HATCH Statut Dessin / Manuel Fournisseur Vendor Drawing / Manual Status	
1	☐ Fabrication autorisée - Dessin et/ou manuel final reçu Fabrication Authorised - Final Drawing and/or Manual Received
2	☐ Fabrication autorisée - Soumettre dessin et/ou manuel final Fabrication Authorised - Submit Final Drawing and/or Manual
3	☒ Fabrication autorisée conditionnelle à l'ajout des changements indiqués; Revoir et soumettre dessin et/ou manuel final Fabrication Authorised - Subject to incorporation of indicated changes; Revise and Submit Final Drawing and/or Manual
4	☐ Fabrication non autorisée - Revoir et resoumettre Do Not Fabricate - Revise and Resubmit
Par/By	Date: 21/01/05
La révision et l'autorisation de fabriquer portent seulement sur la conformité générale à la conception du projet et à l'information disponible dans les documents contractuels. Le fournisseur/entrepreneur demeure le seul responsable de la conformité du document aux exigences des plans et devis, y compris mais sans s'y limiter, aux dimensions et aux quantités. HATCH ne garantit aucune des informations contenues dans les présentes et n'autorise ni n'approuve aucun procédé de fabrication ou technique de construction ou tout

18 CIRCUIT 3Ø DISTRIBUTION PANEL

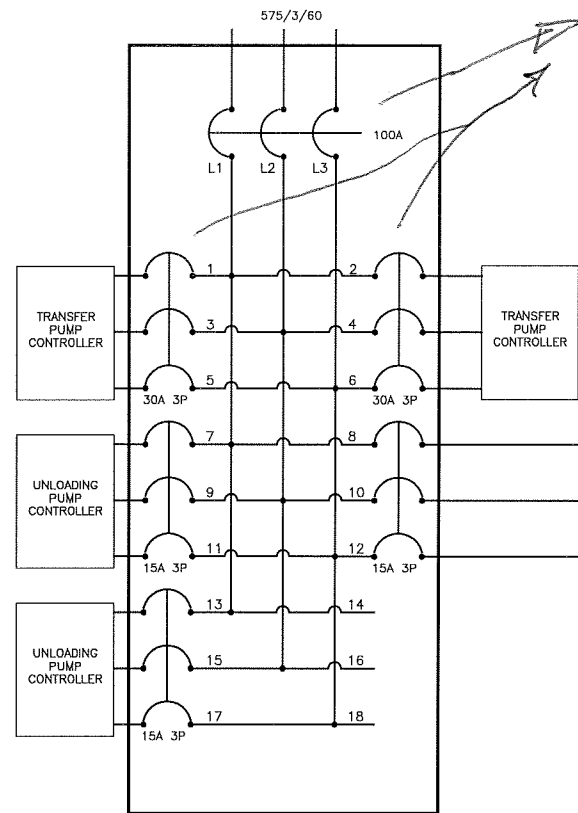
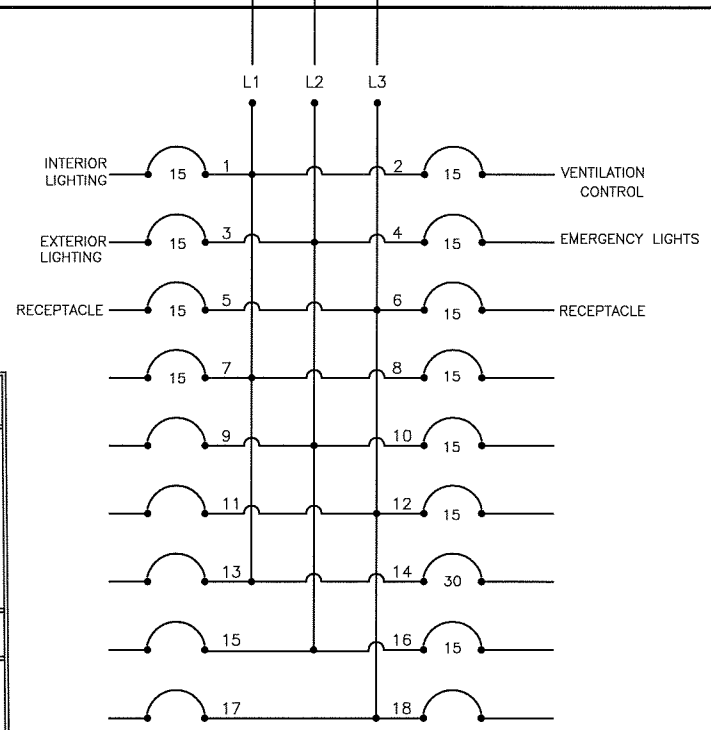
Circuit breaker interrupting capacity to be minimum 42KA @ 600V

ELECTRICAL EQUIPMENTS
MUST BE SUITABLE FOR
OPERATION @ -45°C
ADD HEATER IN PANEL
IF REQUIRED.
